Multiplex for  
UNSW Biological Sciences Project

**S96 (SSD 6674)**  
**Architectural Design Statement**

27 October 2016

Fig. 17 - Proposed S96 Amended North Elevation

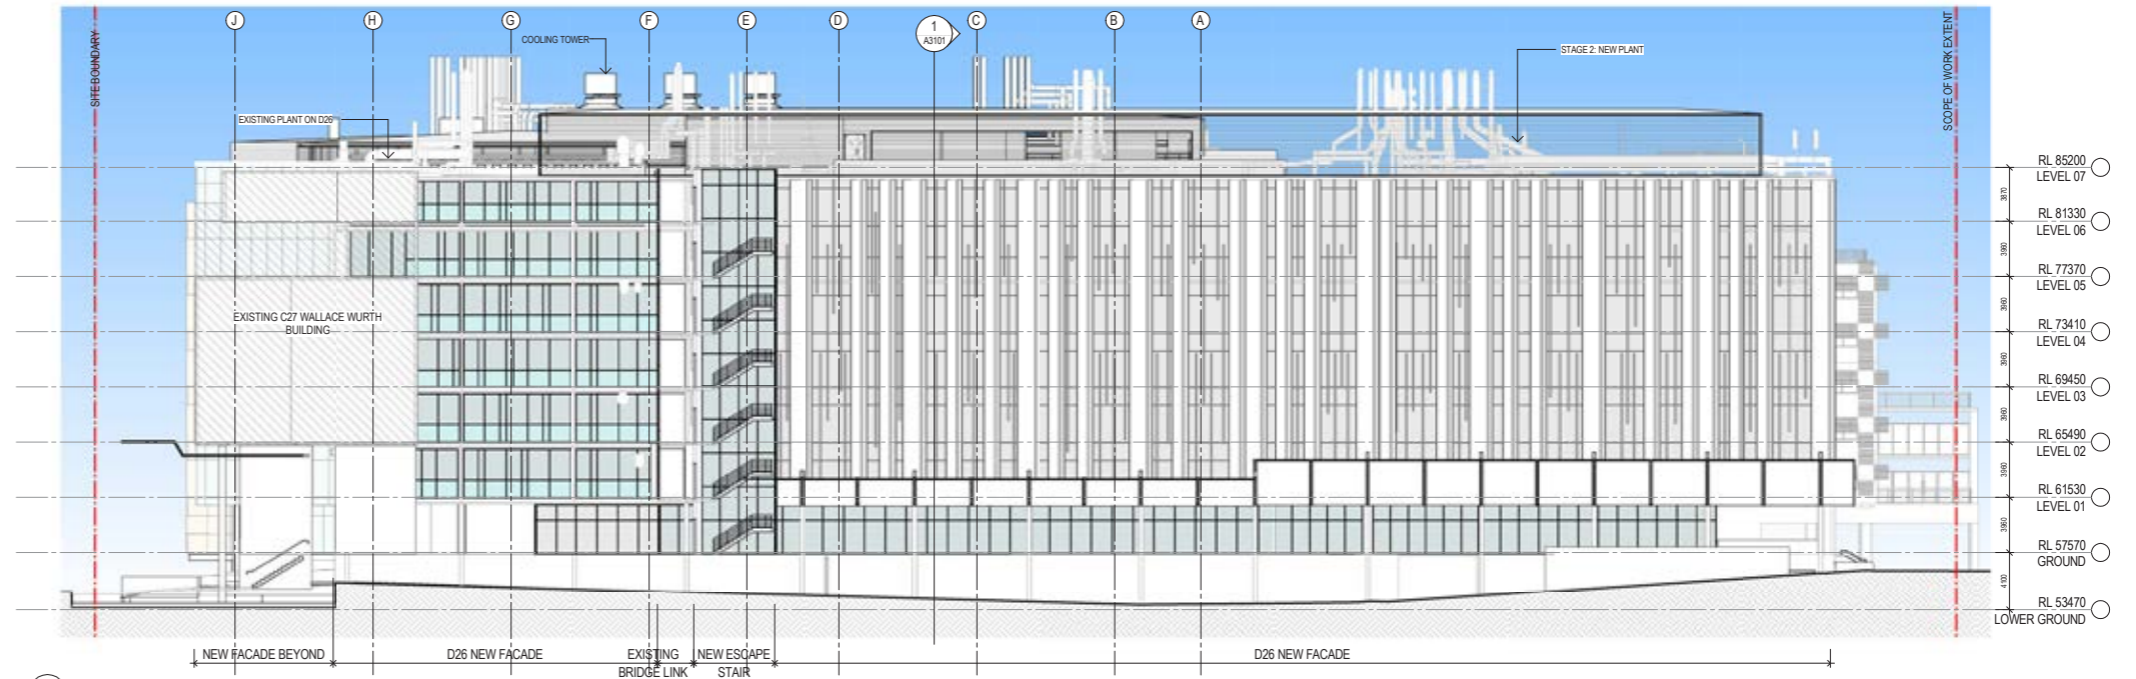
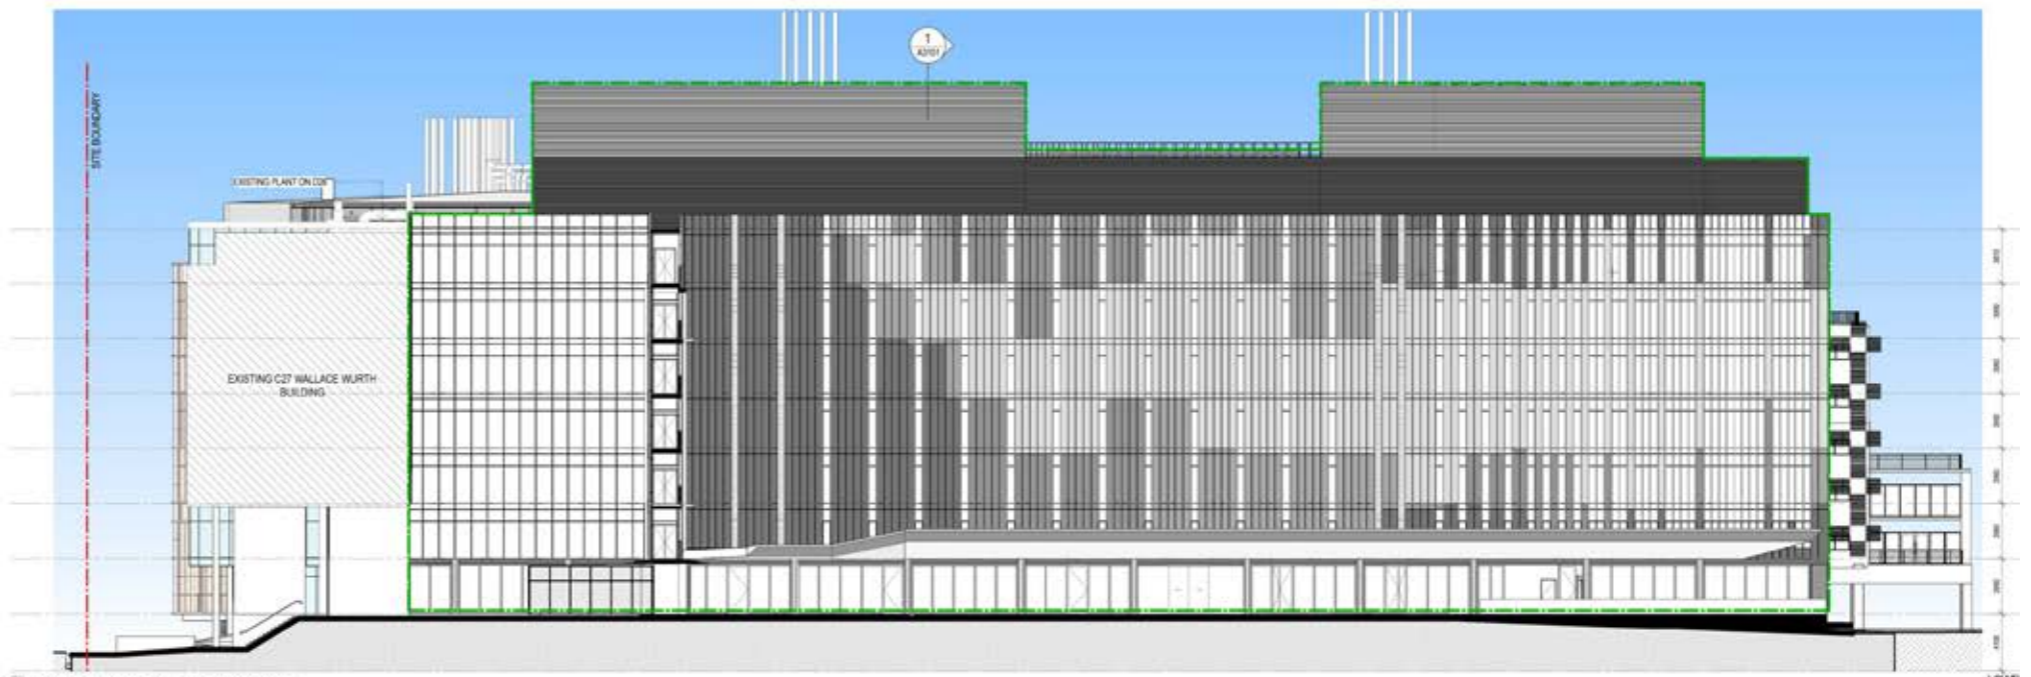
The facade concept of continuing the vertical articulation found in Michael Birt Gardens is retained and continued in the amended facade.

The facade has been developed to address the program in the building now developed as part of the Stage 2 works.

The proposed facade consists of aluminium and glazed panels with vertical solar shading fins. From the junction with Wallace Wurth to the middle of the facade the panels are predominantly aluminium with vertical full height glazed strips addressing the laboratory support function behind.

Towards the west where the function is workplace-based research the pattern gradates to a more glazed solution with more vertical fins to shade the glass.

The rooftop plant enclosure is included and will be the same material and expression as the rooftop plant consented for Building E26.

Fig. 19 - Proposed S96 Amended West Elevation

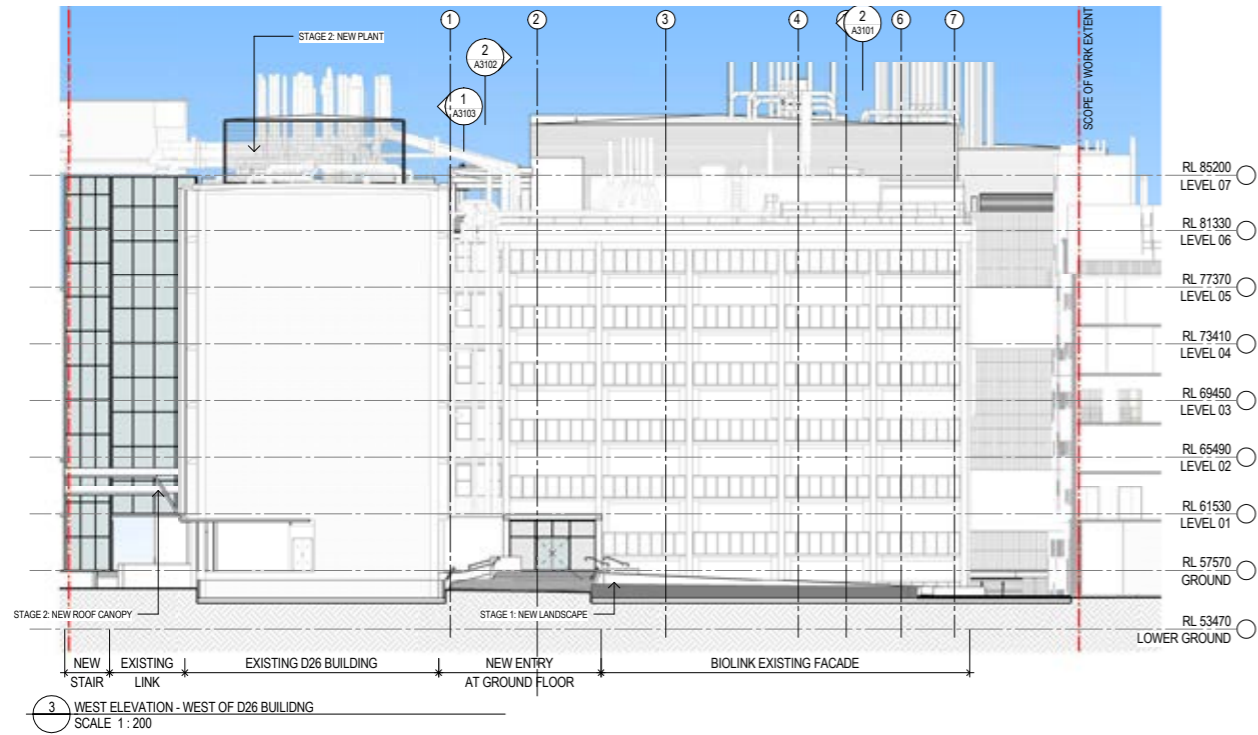
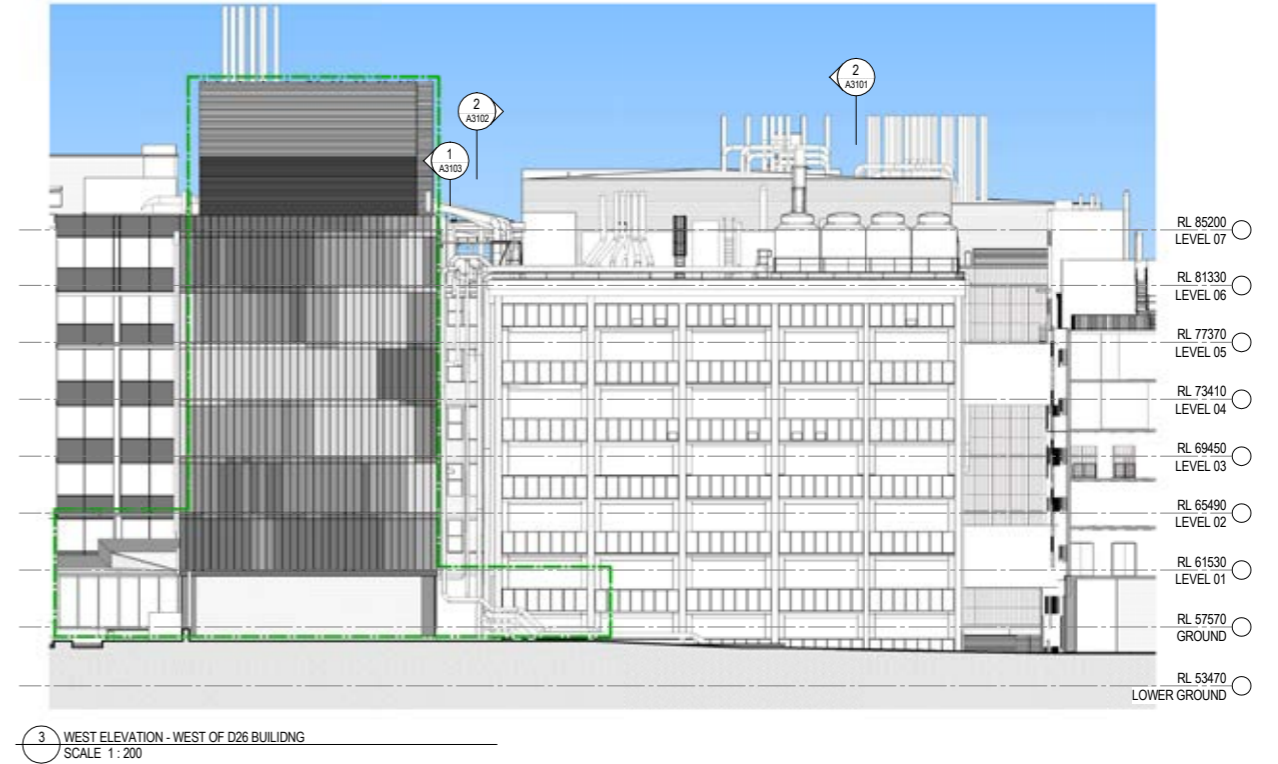
The consented West facade retained the existing red brickwork. Further analysis led to the conclusion that the brickwork was in disrepair and required replacement in the interest of the building life cycle.

The amendment proposes to remove the existing brickwork and use aluminium cladding in continuation of the north facade language.

The base is designed with a dark grey terracotta cladding for durability and to continue the base-middle-top composition established on the north facade.

Fig. 23 - Proposed S96 Amended East Elevation

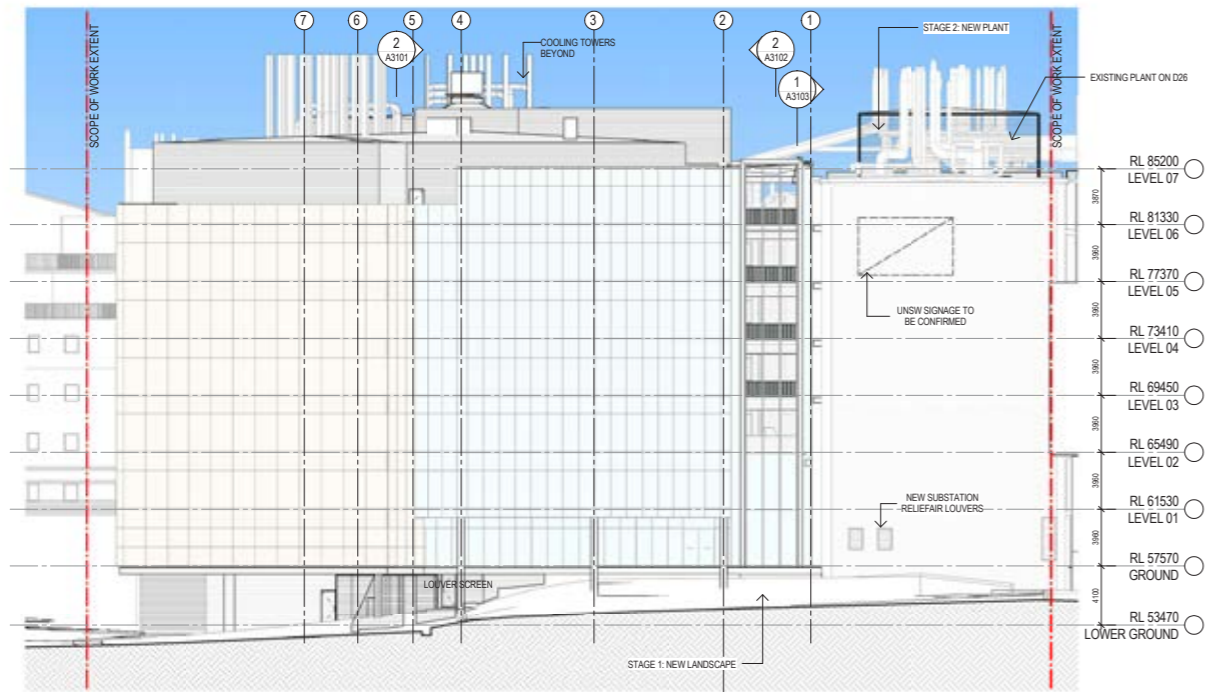
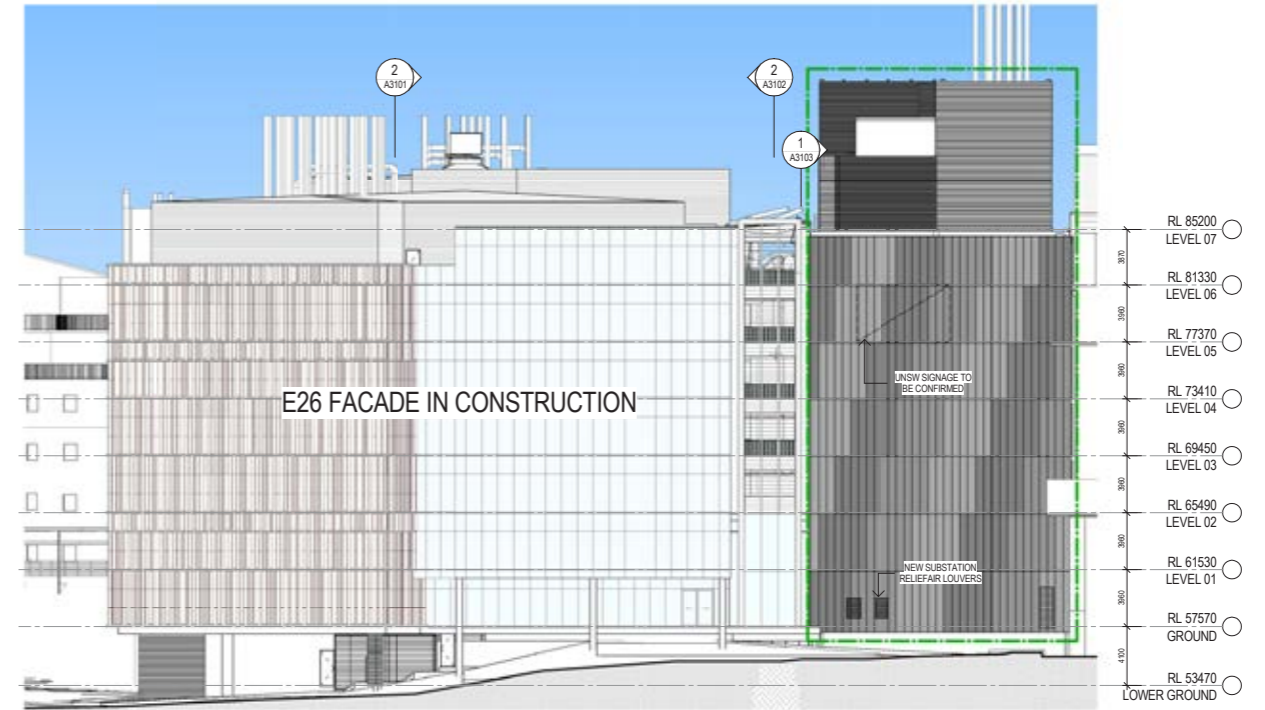
As with the West Facade the consented East facade retained the existing red brickwork, was in disrepair and required replacement.

The amendment proposes to remove the existing brickwork and use terracotta cladding with a similar vertical pattern as with the other facades.

Terracotta is chosen to complement the Terracotta used on Building E26 facade but retains the grey tonal palette to identify itself as D26 in keeping with the other facades of the building.
